DOOSAN Document Transmittal <u>Upper Trishuli-1 HEP (216MW)</u>					Date	DT No.:	SHEET
					2022-04-27	UT1-HEP-DHI-PC-D-0024	1 OF 1
DOOSAN NEPAL BRANCH OFFICE		Address & Contact No. : Four Square Building, Naxal, Kathmandu, Nepal (P.O Box : 1387) + 977 1 692 3014			Project No. H20002	DOCUMENT DISPATCHED BY	
DOCUMENT DISTRIBUTION		☒ POWER CHINA (Subcontractor) ☐ Doosan's Site Office				Courier Service ☐ Messenger ☐ Post-Air Freight ☐ Document System or E-mail ☒ By hand ☒	
SUBJECT		Review Note RN-0114_Reinforcement Drawing of Inlet Structure of Diversion Tunnel

REVIEW NOTE

Contractor	Doosan Enerbility		
Title of the Document	Reinforcement Drawing of Inlet Structure of Diversion Tunnel, sheets 1-4		
Document No.	UT1-C-010-CVL-DG-42004	Revision	0B
Date of Documents	14.04.2022	Received Date	19.04.2022
Transmittal Form No.	UT1-HEP-DHI-D-0207		
Previous Review Date/Status	26.03.2022/RR	Prev. Review Note No.	RN-0100
Review Note No.	RN-0114	Present Review Date	26.04.2022
		Present Review Status	RR

Comments to UT1-C-010-CVL-DG-42004, sheet 3 of 4

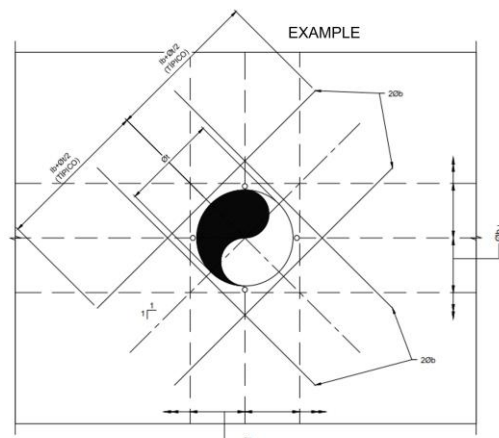
- Details of air vent pipe reinforcing:
Circular re-bar "type a" is not suitable as the air vent pipe is not pressurized under operation.
An example as a standard detail is shown in the sketch below:
